Northwatch Comments on Ontario Power Generation Inc.'s Application for a Licence to Construct BWRX-300 reactor(s) at Darlington Nuclear Generating Station

November 2024 Ref. 2024-H-03

Figure 5: An Artist Rendition of a Potential BWRX-300 Layout

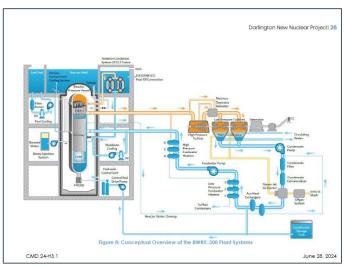
Figure 5 in OPG's CMD is the most "readable" of the graphic presentations and identifies two features of

the BWRX layout related to nucleaer waste and its management: the "Radwaste Building" and the "Proposed Spent Fuel Storage" (but not the "Fuel Pool"). Figure 8 identifies the "Fuel Pool", but not the Radwaste Building or Proposed Spent Fuel Storage.

As summarized above, the Application provides no description of those aspects of the building most related to its function as the location of radioactive wastes, such as shielding, robustness from extreme weather or malevolent acts, or the design and security of the actual waste containers being housed.

REQUEST: That the Commission deny the application to construct on the basis of OPG having provided inadequate information about their reactor design, including the design, design features and design basis for those parts of the site layout related to radioactive waste and its containment, including the Radwaste Building, the Spent Fuel Storage and the Fuel Pool

Figure 1: OPG CMD page 38

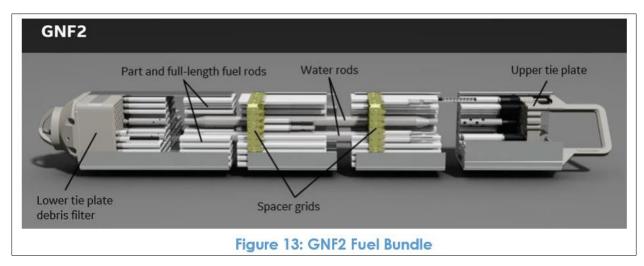
While Section 2.2 of the CMD includes a brief description of the fuel, the fuel assembly and the fuel cycle, there is no description of this same fuel after it has been irradiated and become high-level nuclear waste, or of the management structures that must be constructed – under this license application – to house the resulting waste.

Figure 2: OPG CMD 24-H3.1, page 17

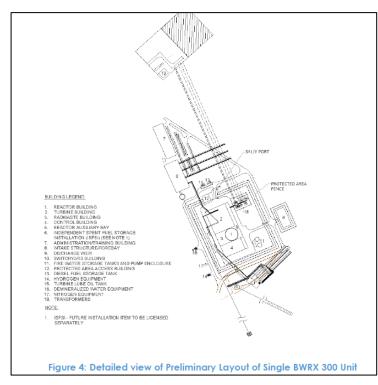
OPG claims in their CMD that "the dry fuel storage practices will reflect the fundamental safety aspects related to criticality, radiation exposure, heat control, containment and retrievability" but has provided no information or evidence to support that claim. Moreover, it appears in Figure 4 in CMD 24-H3.1 that the (future) used fuel storage facility is outside the protected area.

REQUEST: That the Commission defer further consideration of the application to construct until such time as OPG has submitted addressed the gaps and deficiencies in their application with respect to radioactive waste management and its facilities, including the design details of those facilities which will

be constructed prior to operation commencing, and adjustment of the site configuration to correct the current placement of the future fuel waste storage being outside the protected area.
